Access Compliance Report

Public Rights-of-Way

(Curb Ramps)

Intersection ID: 49797	Main Street: ATKINS RIDGE DR	Cross Street: PARSIFAL LN	Location: E
ADA ID: 9C76F1E439B8	Ramp Type: PerpDiag	Initial Pass/Fail: Fail	Overall Compliance: No
Severity Score: 10			
Codes/Mitigation Info/Possible Solution		Field Measurements/Component Compliance

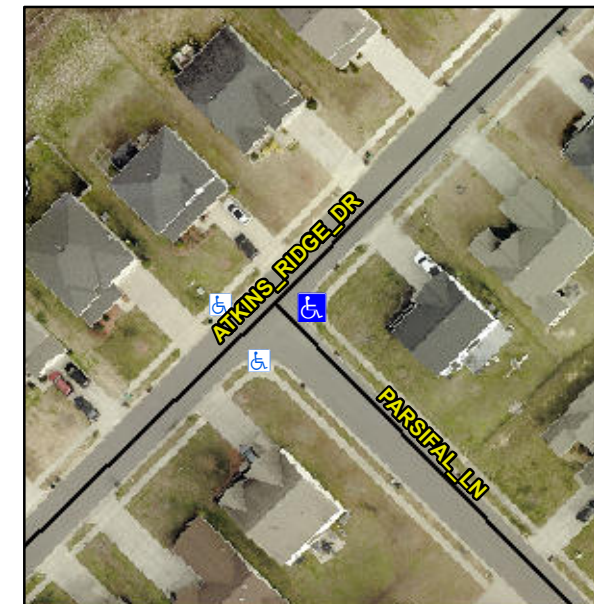
Not Found, R304.5.1, R304.5.3

Compliance	Description	Data	Compliance	Description	Data
N/A	Ramp Length (in)	47.0	Yes	Ramp Slope (%)	6.3
No	Ramp Width (in)	41.0	No	Ramp XSlope (%)	4.1
N/A	Flare Type LT	N/A	N/A	Flare Type RT	N/A
N/A	Flare Slope LT (%)	N/A	N/A	Flare Slope RT (%)	N/A
N/A	Flare Traversable LT?	N/A	N/A	Flare Traversable RT?	N/A
N/A	Landing Length (in)	N/A	N/A	DWS Provided?	N/A
N/A	Landing Width (in)	N/A	N/A	DWS Contrast?	N/A
N/A	Landing Slope (%)	N/A	N/A	DWS Length (in)	N/A
N/A	Landing X Slope (%)	N/A	N/A	DWS Full Width?	N/A
N/A	Landing Curb? (Y/N)	N/A	N/A	DWS Offset (in)	N/A
N/A	Shared Landing?	N/A			
N/A	Gutter Ponding?	N/A	N/A	Gutter Slope (%)	N/A
N/A	Gutter Lip Ht (in)	N/A	N/A	Gutter X Slope (%)	N/A
N/A	Painted X Walk1?	No	N/A	Painted X Walk2?	No
	X Walk 1 Direction	To NW		X Walk 2 Direction	To SW
N/A	X Walk 1 Width (in)	N/A	N/A	X Walk 2 Width (in)	N/A
	X Walk 1 Slope (%)	0.8		X Walk 2 Slope (%)	1.4
	X Walk 1 X Slope (%)	2.1		X Walk 2 X Slope (%)	0.4

Remove & Replace Curb Ramp With Two New Directional Ramps or Equivalent.
